MEMORANDUM

Claim on Contract 72-216 by Becker Drills Ltd.
Rock Slotting, Thorold Tunnel
Hwy. 58 and Welland Canal
District #4 (Hamilton)
W.O. 72-11096 -- W.P. 48-72-02

Attached we are forwarding to you our report
regarding the above-mentioned claim.

FIG. 2 W.O. 72-11096

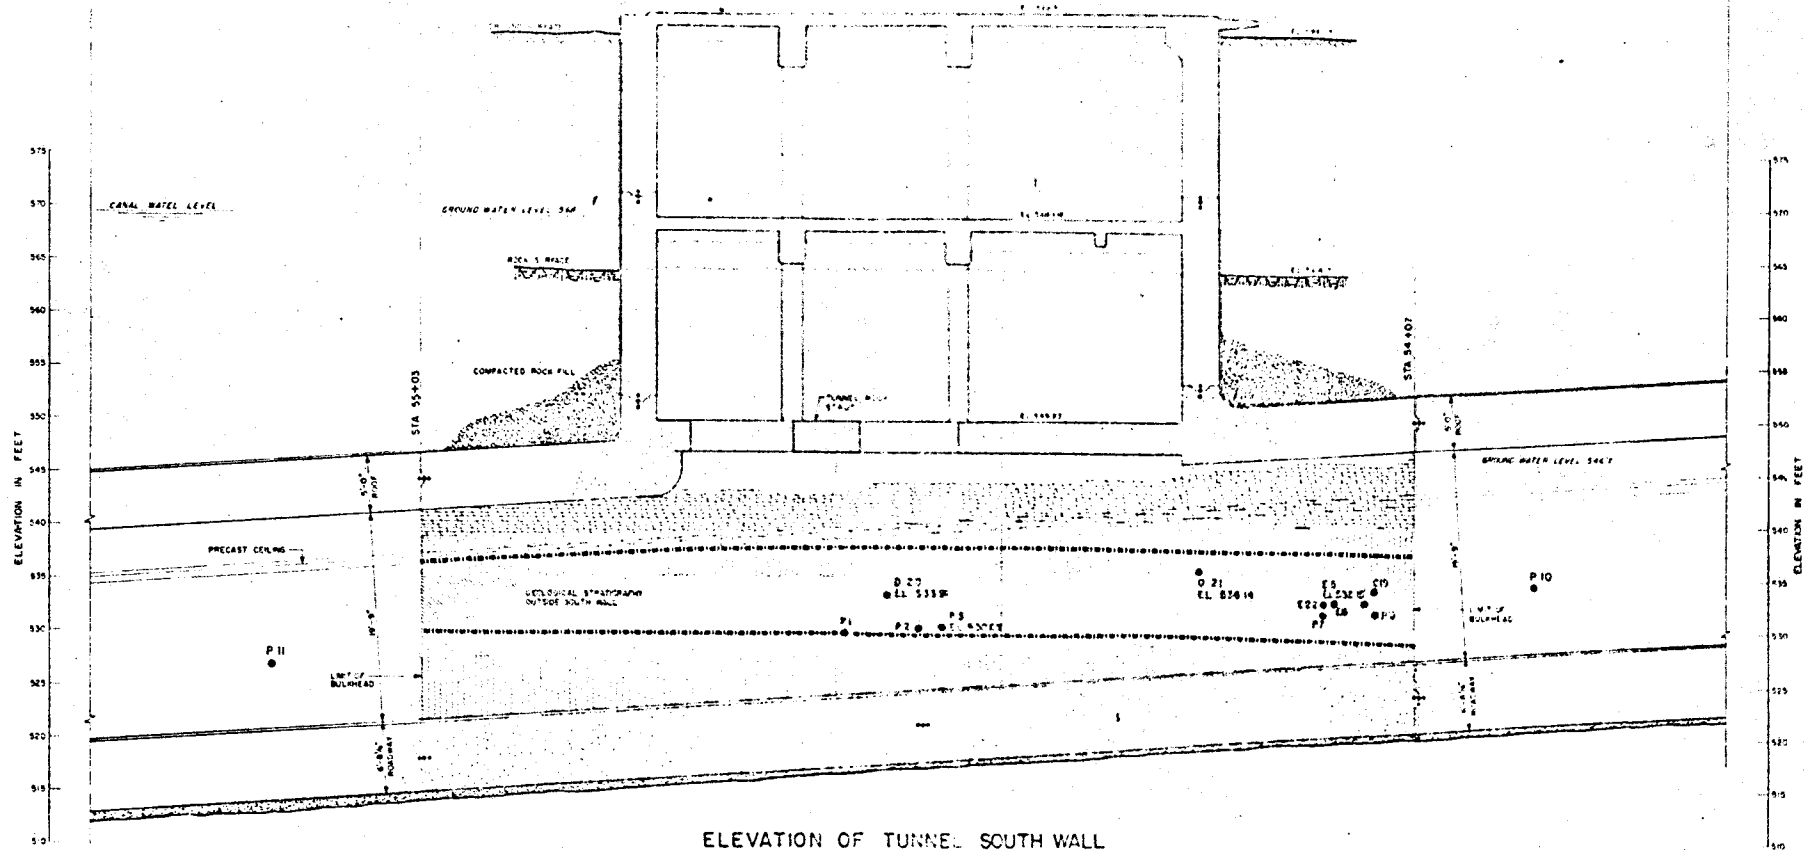
- a) This Office reviewed critically the rock core samples obtained in two boreholes (#I-1 & #I-2) approximately 3 feet from the proposed slot. The locations of these two boreholes are shown on Fig. 3 in Appendix 2. These two boreholes were put down for installation of various instrumentations to monitor the rock movement. These borings were drilled after the award of this contract. The core samples (HQ size, approximately 2-1/2 inches diameter) only exhibited minor vertical jointing and fracturing in the upper 20 feet. Based on this information, it can be inferred that the bedrock is not badly shattered and cracked as claimed by the Contractor.
- b) The Contractor originally proposed to drill the slot in a continuous fashion, using overlapping 6-1/4" diameter
